BUNDLE 8: Access, car parking and highways – 08/08/25

**The Old Vicarage, Homington Road, Coombe Bissett,
Salisbury, Wiltshire SP5 4LR**

**Proposal: Replace existing dwelling with a new dwelling,
hard and soft landscaping, ecological and tree mitigation**

Planning Application
[PL/2024/09412](#)

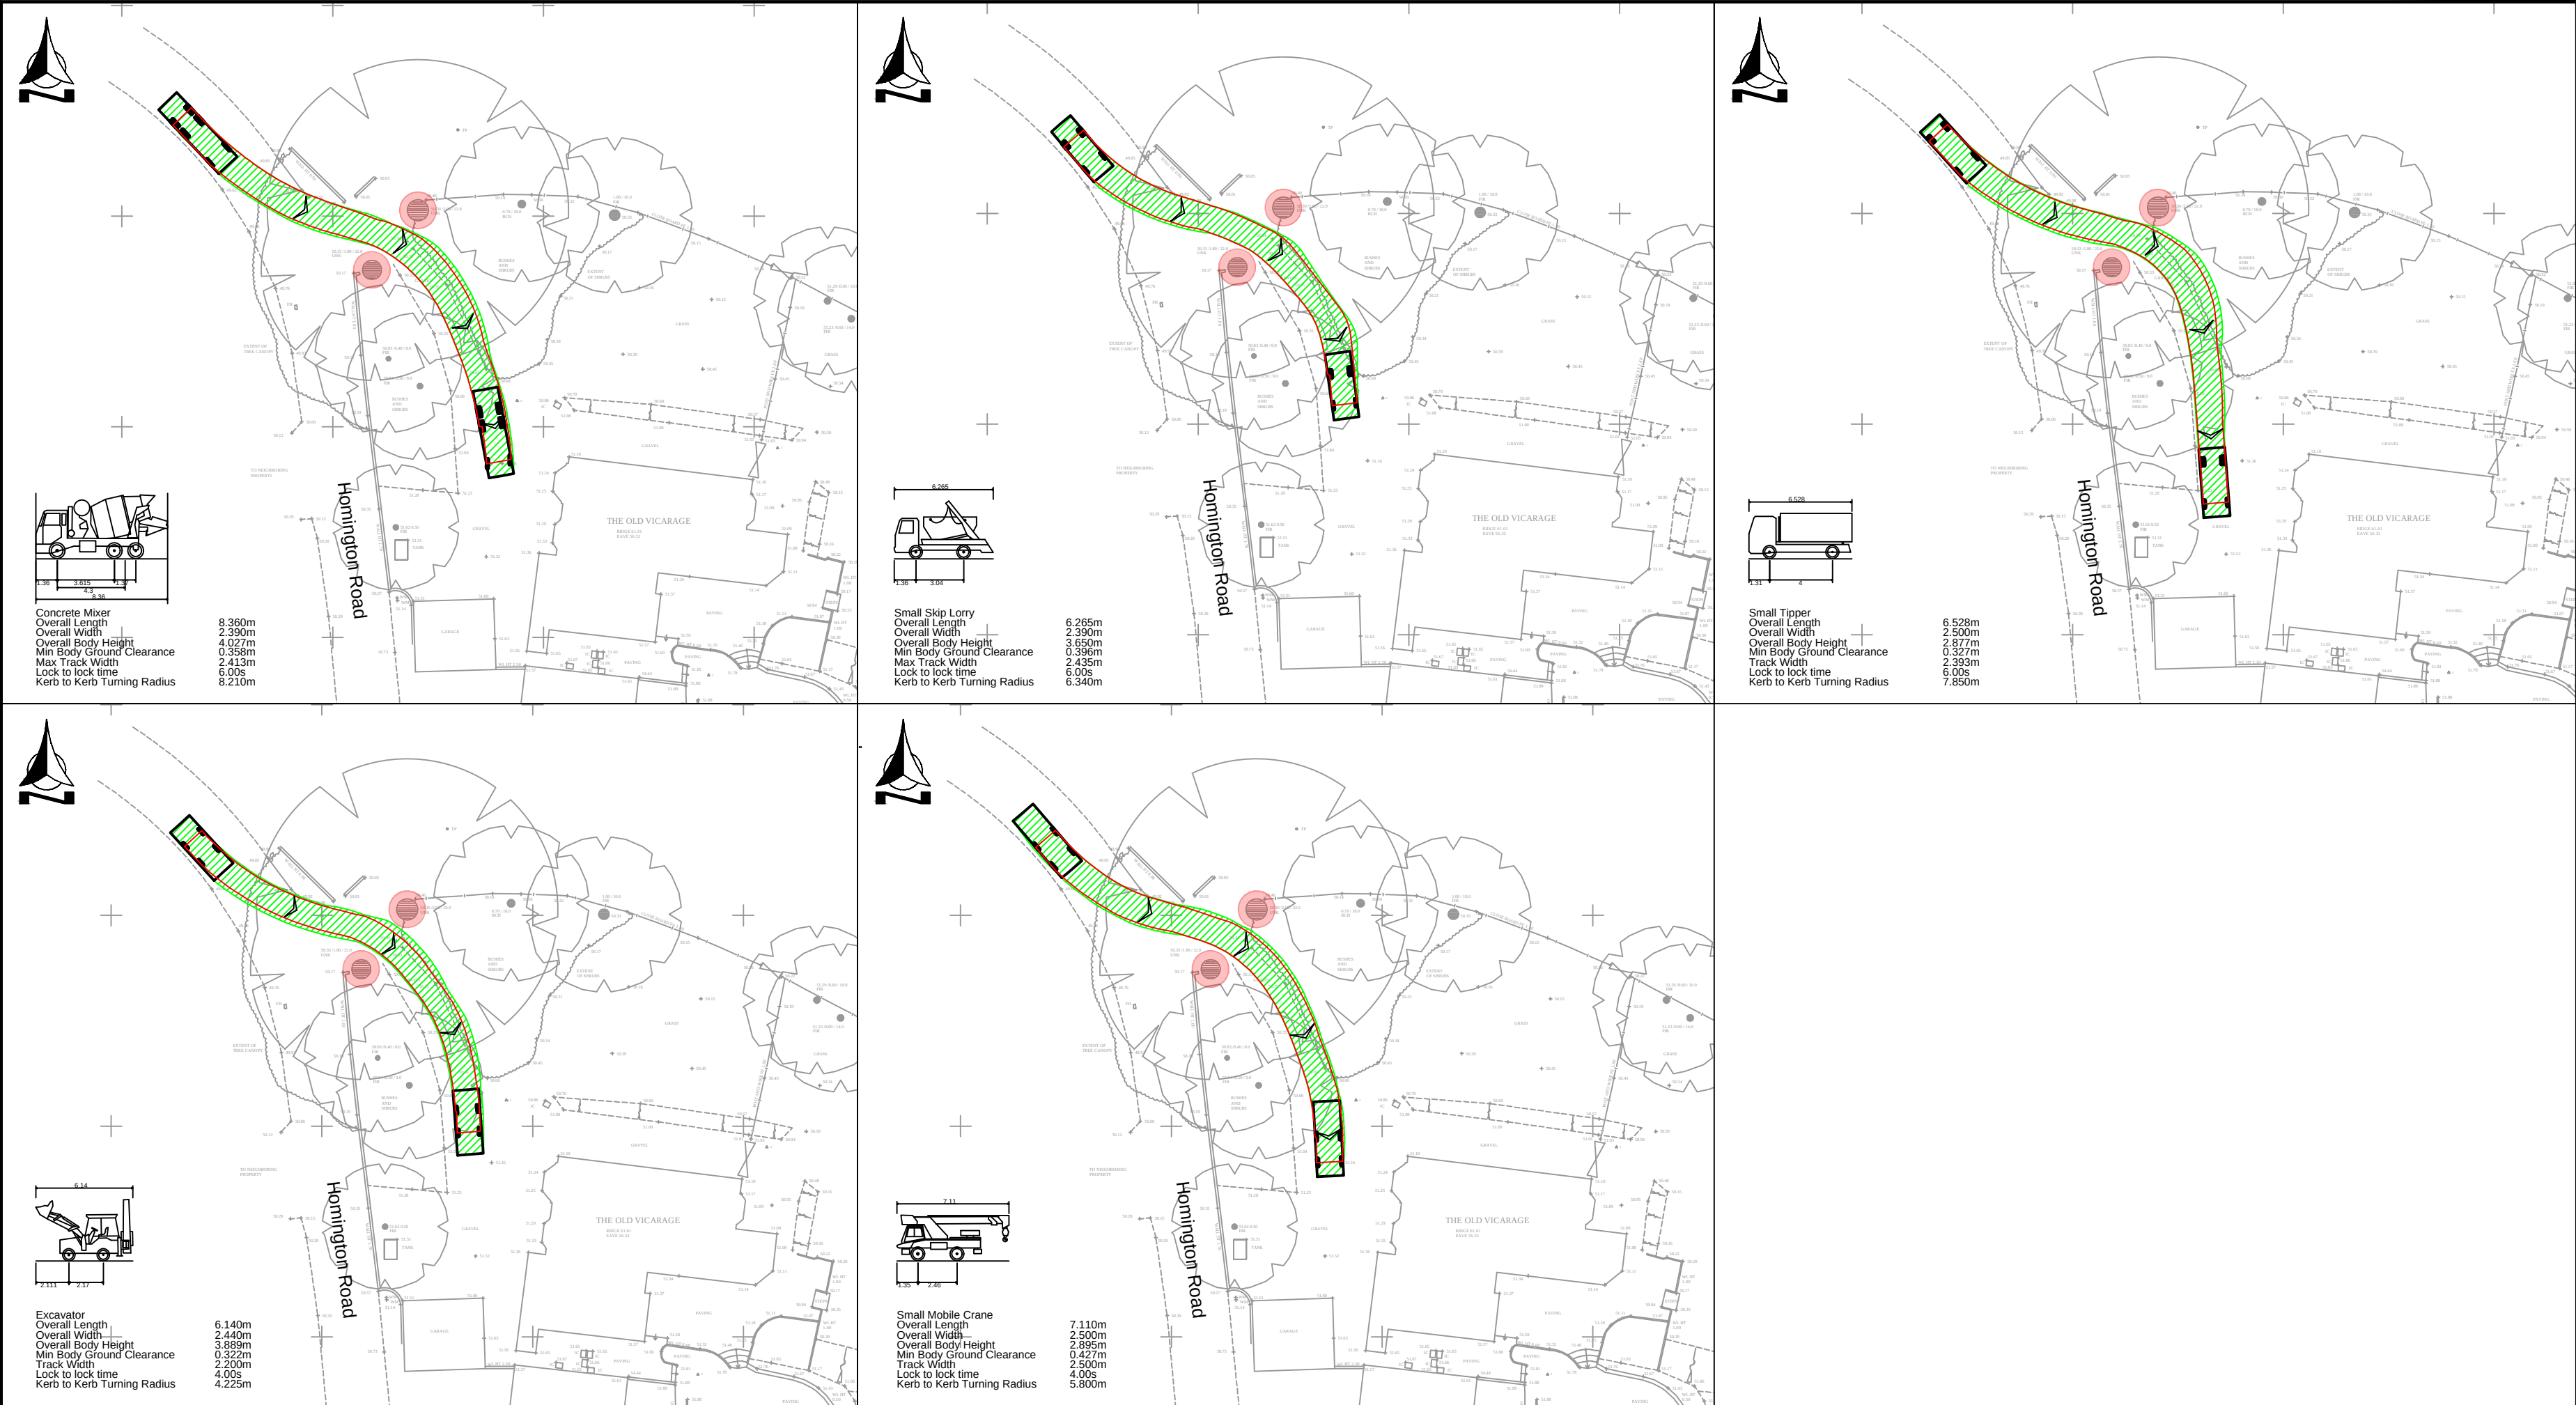
The site is accessed off the classified C12 and the vehicle access into the site is not proposed to be altered as part of this application.

The proposal includes adequate off street parking to meet Wiltshire's current parking standards.

I wish to raise no highway objection providing the following condition is imposed:

No part of the development hereby permitted shall be first occupied until the parking spaces [3] have been completed in accordance with the details shown on the approved plans. The areas shall always be maintained for those purposes thereafter and maintained free from the storage of materials.
REASON: In the interests of highway safety.
